**CULTURAL RESOURCES OFFICE
PRESERVATION BOARD
REGULAR MEETING
MONDAY AUGUST 22, 2011
1015 LOCUST ST. #1200
4:00 P.M.**

DATE: August 22, 2011
FROM: Andrea Gagen, Cultural Resources Office
SUBJECT: Preliminary Review: new single-family construction on two vacant lots
ADDRESS: 3927 & 3929 Shenandoah Avenue
JURISDICTION: Shaw Neighborhood Historic District — Ward 8
PREVIOUSLY HEARD: November 24, 2008

DATE: August 22, 2011
FROM: Jan Cameron, Preservation Administrator
SUBJECT: Appeal of staff denial: to erect a wall sign with electronic reader board on a one-story commercial building
ADDRESS: 1801 Russell Avenue
JURISDICTION: McKinley Heights Historic District — Ward 7

DATE: August 22, 2011
FROM: Bob Bettis, Cultural Resources Office
SUBJECT: Appeal of a staff denial to install a sign on a Public Facade
ADDRESS: 2021 E. Grand Ave.
JURISDICTION: Hyde Park Local Historic District — Ward 3

STREET ELEVATION SHOWING THE DESIGN IN CONTEXT WITH EXISTING FABRIC.

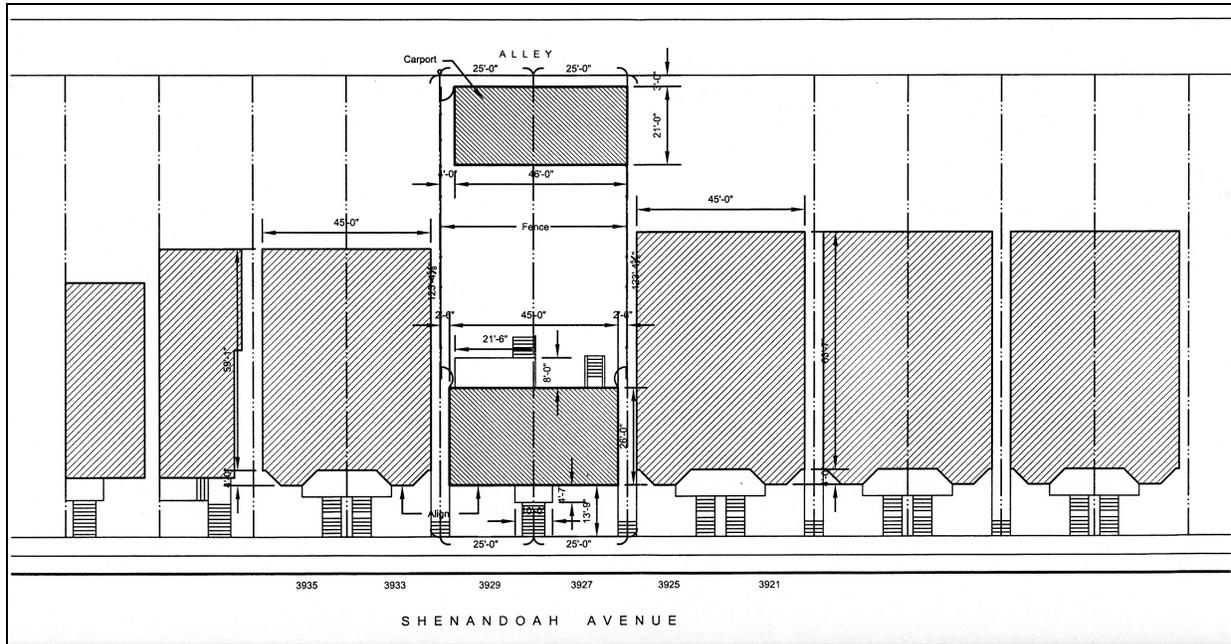
Partially complies. The building currently is not within 15% of the average height of buildings on the block due to the roof height, which the applicant has agreed to reduce. The floor heights appear similar to adjacent buildings.

Partially complies. The width and spacing of the proposed building is appropriate for the block. However, the building, as currently sited, sits 4 feet in front of the main masses of the adjacent buildings. These flanking buildings establish a uniform setback context for the proposed residence and should guide its placement. The placement of the building also affects the design of the approach to the building in steps and landings, a component of the design that needs to be compatible with the neighboring properties.

- Moving the building back 4 feet so that it is in line with the main masses of the adjacent buildings;
- Reducing the height of the roof;

PROPOSED FRONT ELEVATION

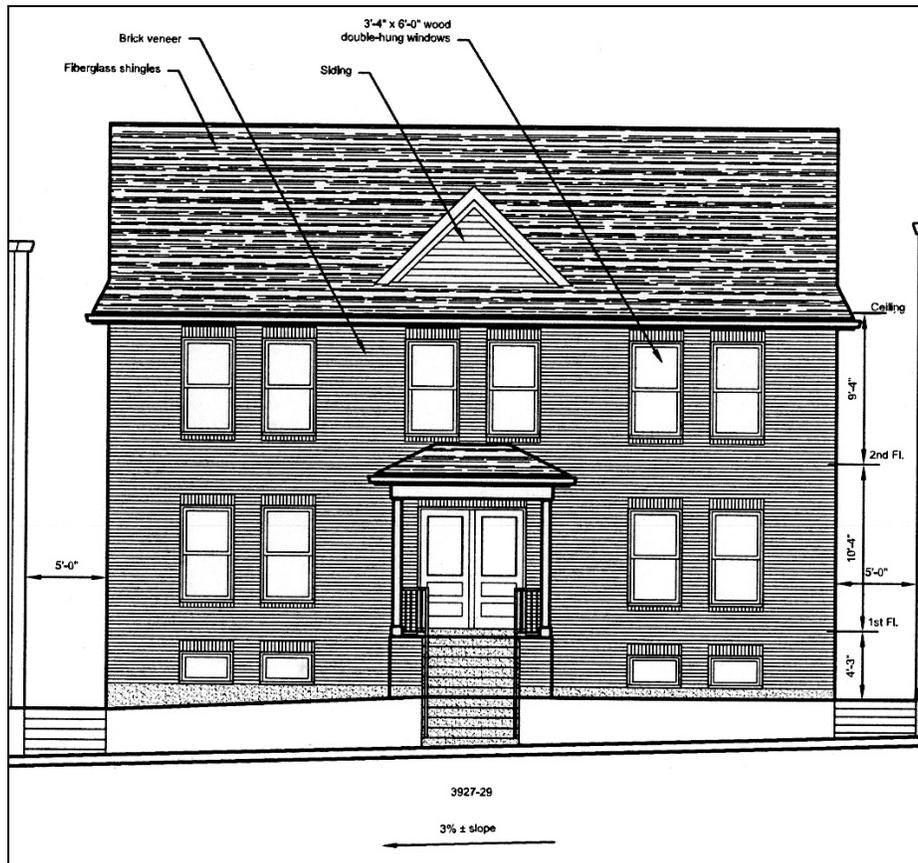
Partially complies. The front elevation and short side returns will be brick; however, the original plans call for only 3 feet of return, resulting in part of the non-brick side walls being visible from the street.

The currently proposed material on the front gable face does not comply.

However, the front porch is proportionally undersized in regard to the scale of the building.

- Extending the brick returns on the sides of the building (the distance required is dependent on the setback of the building);
- Moving the small front gable, or adding another; changing the gable face material to stucco-board or a similar material; and
- Widening the front porch.

RENDERING OF PROPOSED SIGN

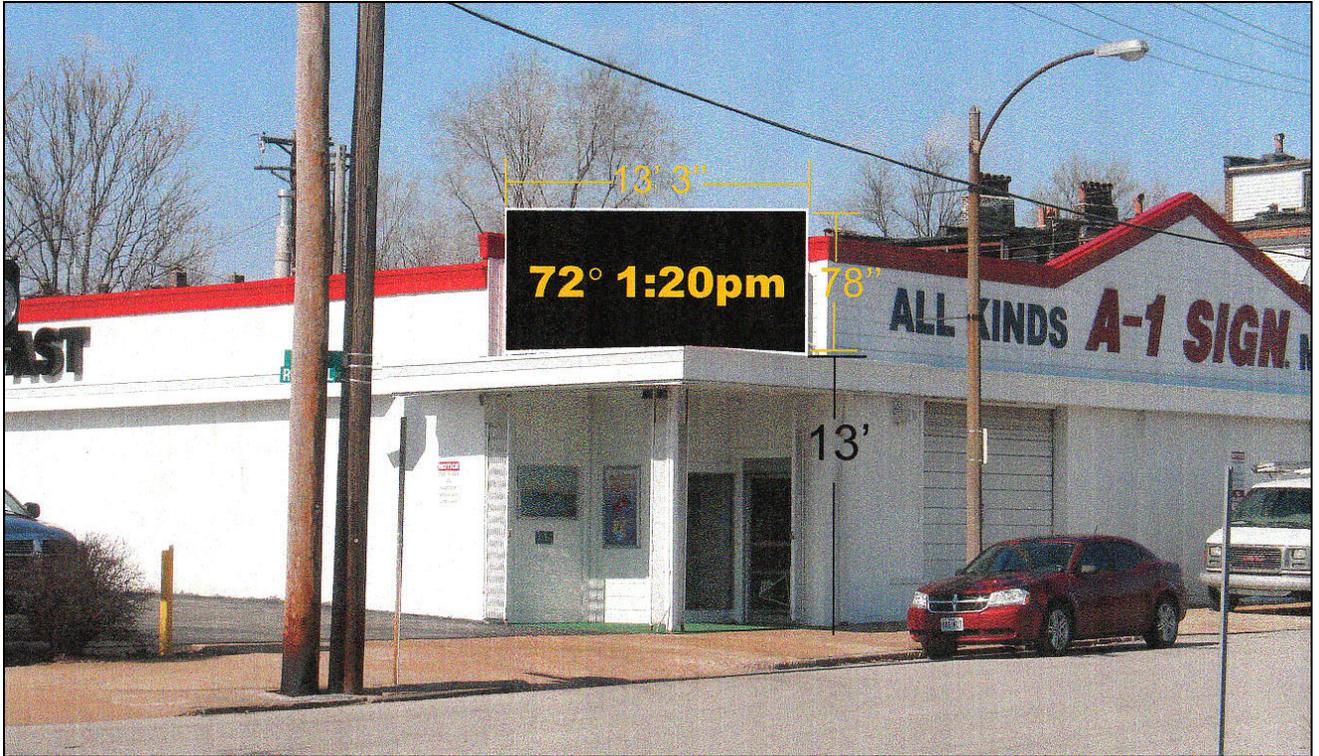
Does not comply. The total area of the sign is slightly larger than 86 square feet.

Does not comply. Although the existing commercial building is not a contributing resource to the local historic district, it does display some architectural character with an oblique recessed corner entry, parapets with center gablets and a projecting canopy that wraps the building's south and east elevations. The proposed sign (and the existing sign as well) interrupts the line of the parapet and conflicts with the design of the corner entry.

Does not comply. Sign violates ii and iv.

Does not comply. Colors, fonts, text and graphics will alternate and announcements will change on a regular basis.

Staff recommends that the Preservation Board deny the application as currently proposed, as it does not comply with the McKinley Heights historic district standards.

LOCATION OF SIGN INDICATED

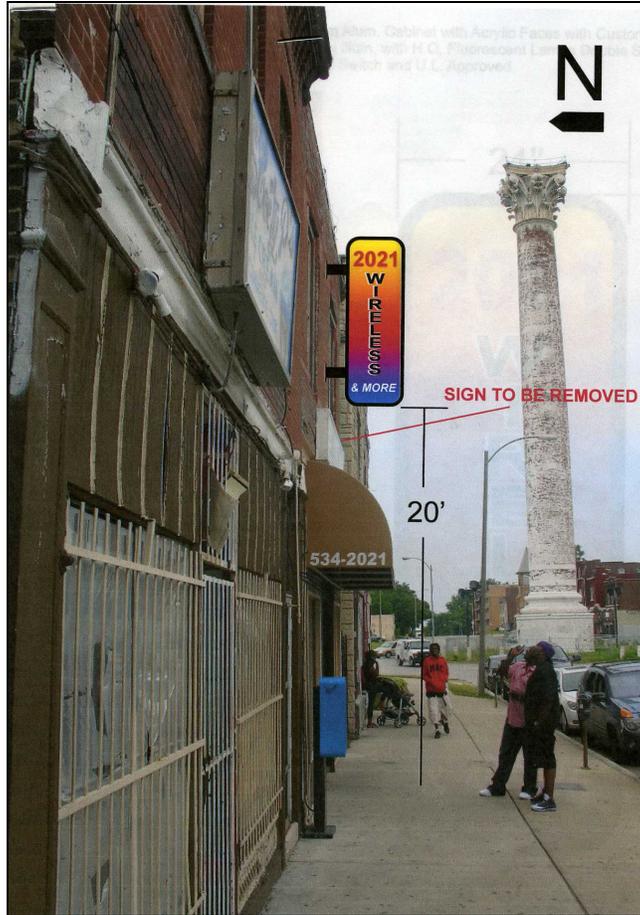
Does not comply. The proposed sign is to be located above the second floor window sill. The large internally lit sign does not complement the existing building and will be a visual detractor from the nearby White Water Tower.

The Cultural Resources Office denied the sign application as it does not comply with the Hyde Park historic district standards which require signs be located below the second floor window sill. The existing signs on the group of commercial buildings on E. Grand are similar in scale and all meet the standards. In addition to not meeting the standards, the proposed internally lit sign would introduce a new type of sign, would be out of scale with existing signs, and would detract from the overall appearance of the façade and block face.

The Cultural Resources Office recommends that the Preservation Board uphold the staff denial of the proposed sign does not comply with the Hyde Park Historic District standards.
